Planning Commission Staff Report

Subject: Rezoning Vote Report

Location: 16861 Chesterfield Airport Road

Petition: P.Z. 34-2007 Blue Ocean (Johnny Y Properties)

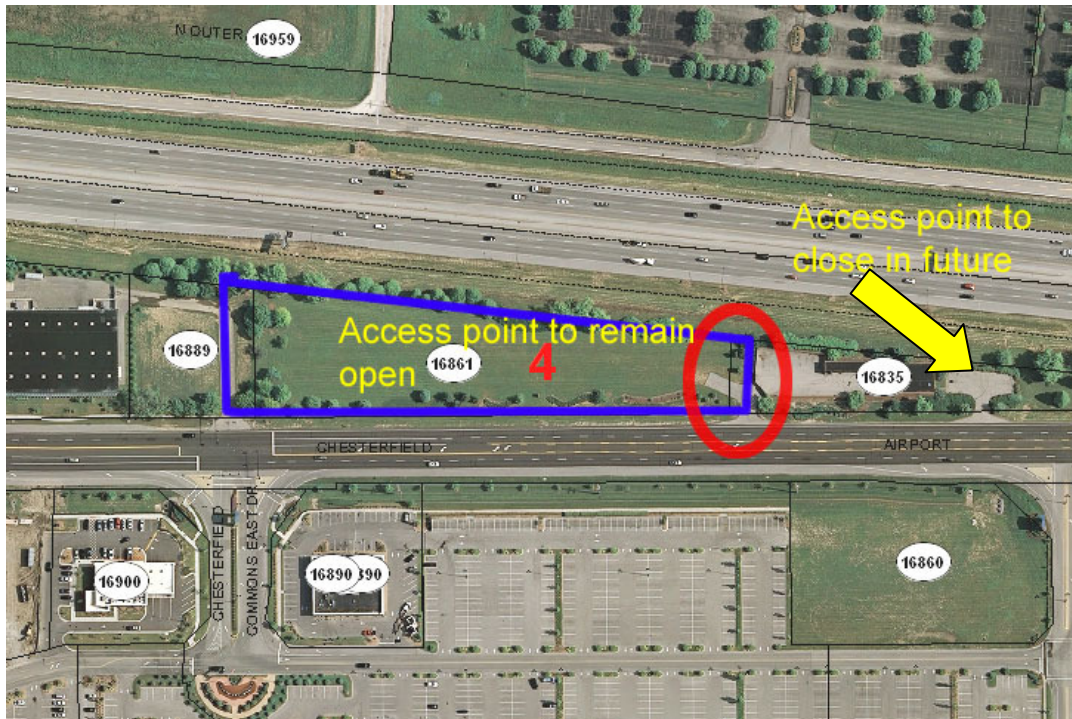
An issue was raised regarding the access to the site from Chesterfield Airport Road; specifically the access on the easternmost end of the site. Below is a rendering which depicts that existing access which is shared with the Sach's Maintenance Facility (and is circled in red). The Department of Planning and Public Works has communicated to the Petitioner that if at such time the Sach's Maintenance Facility site comes in to develop, the City will request that the access point on the east side of the Facility building be eliminated. Petitioner has agreed with to eliminate this easternmost access point when the site comes in to be developed.

A PRELIMINARY DEVELOPMENT PLAN OF BLUE OCEAN

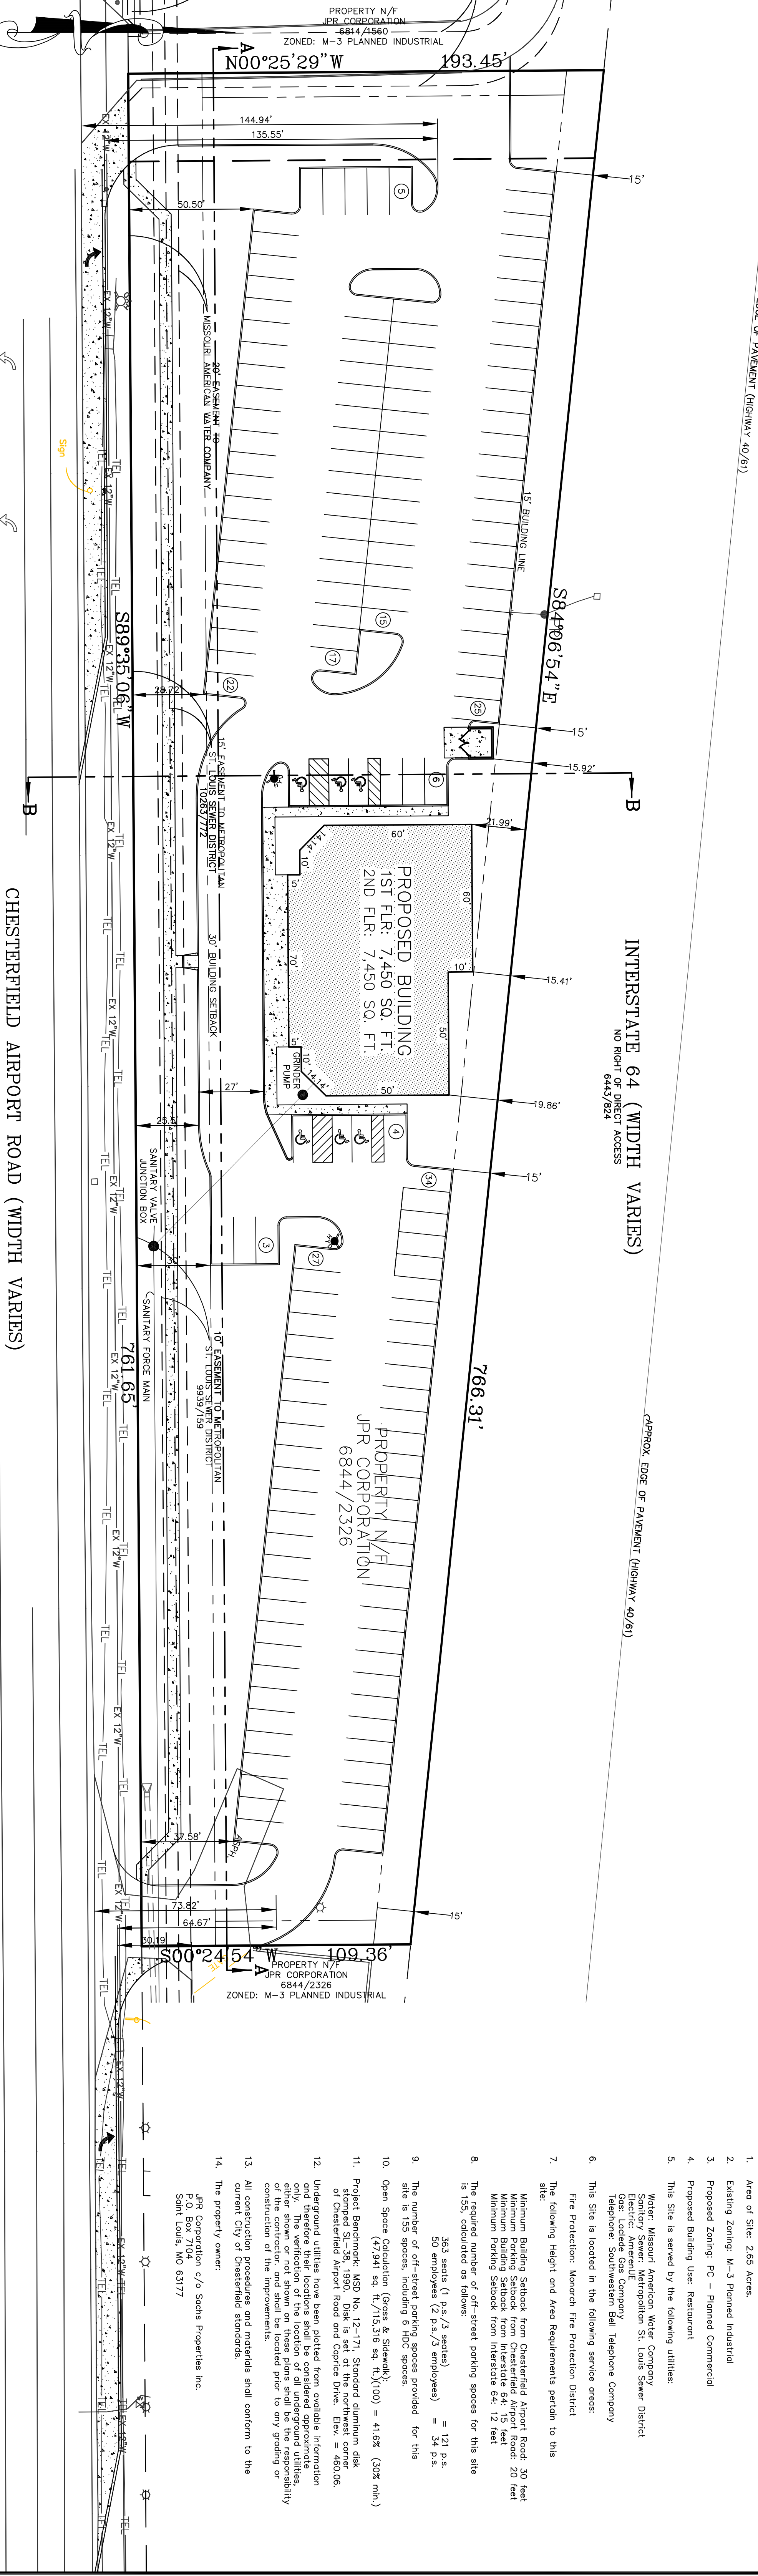
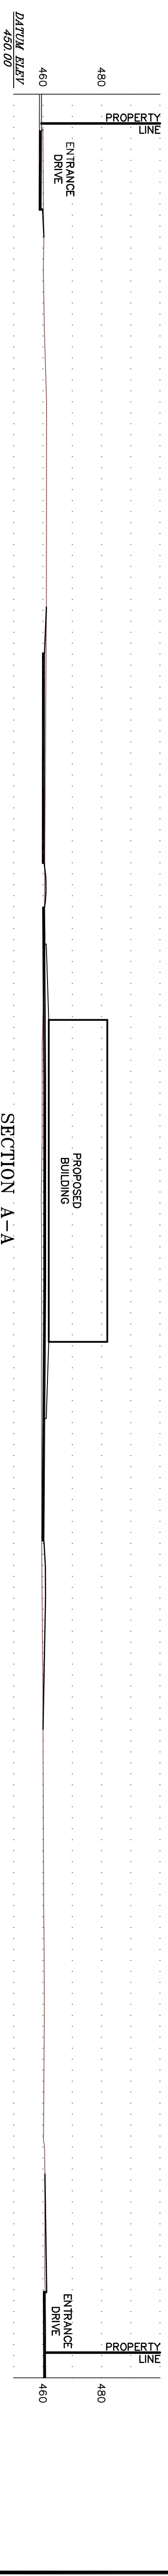
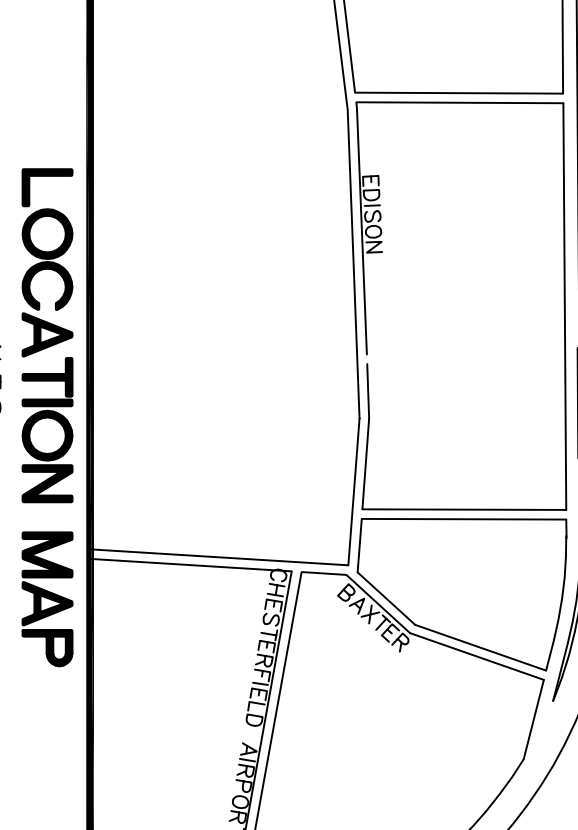
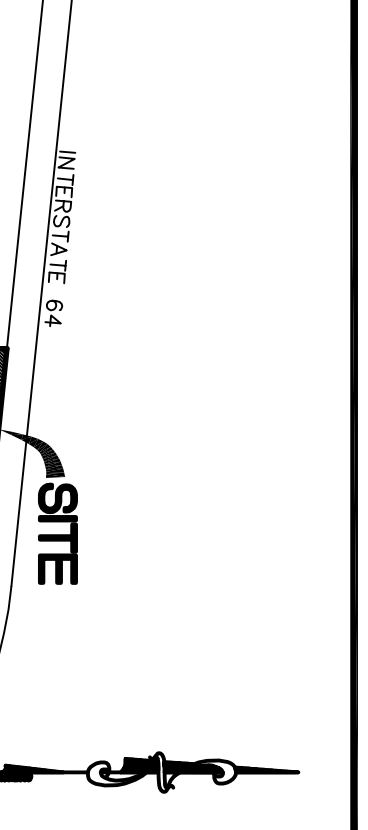
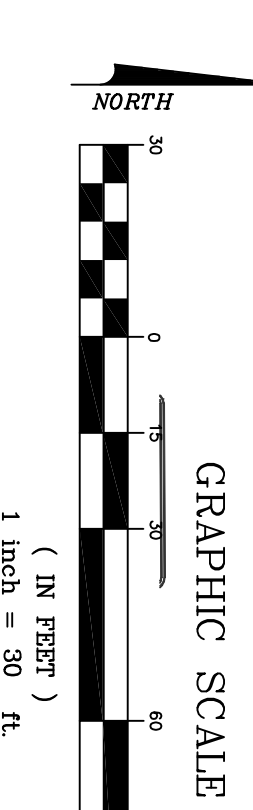
1. There is concern regarding the vehicular and pedestrian circulation throughout the site.
Response: Petitioner has made the changes to the site plan requested by Monarch Fire to meet their minimum turning radii. Petitioner believes the revised site plan, submitted herewith, otherwise complies with the requirements of the City of Chesterfield and provides adequate, safe and appropriate circulation for both vehicular and pedestrian traffic.

2. Address the concern regarding both of the access points for this development. Specifically, concern regarding the access point on the eastern end of the development site.

3. Parking spaces on the east side of the site should not be situated so that cars will back into the entrance drive.

4. Provide comments/approval from the Monarch Fire Protection District.

Response: The access proposed on the west side is a shared access for both the subject site and the Kemp Museum property to the west and is centered across from the existing access on the south side of Airport Road. The access, as proposed, meets St. Louis County Traffic's requirements and Chesterfield's requirements, as well as Monarch's requirements in all respects. The access proposed for the east side of the subject property is an existing access, and provides access to the subject site as well as the existing site to the East. As Mike Geisel indicated, Petitioner would agree to the elimination of the existing second access on the east side of the adjacent parcel, if and when that property is redeveloped, and use the proposed access as shown on the site plan for access to both parcels. Elimination of the current proposed east-shared access would result in significant loss of parking, making the proposed use economically unfeasible.

Response: The revised site plan eliminates the parking stalls that create the conflict.

Response: Petitioner has met with David Nichols of Monarch Fire Protection District, who reviewed and agreed on the necessary changes to the internal drive radii. The revised site plan modifies the turning radii in a manner to meet their requirements. A copy of Monarch's specifications and requirements are attached. The revised site plan has been provided to Mr. Nichols, and he has agreed to make every effort to respond to the revised site plan before the next meeting of the Commission, but could not provide a response today. We hope that the attached specifications will allow staff to confirm that the revised site plan does meet Monarch's requirements and address their previous comments.
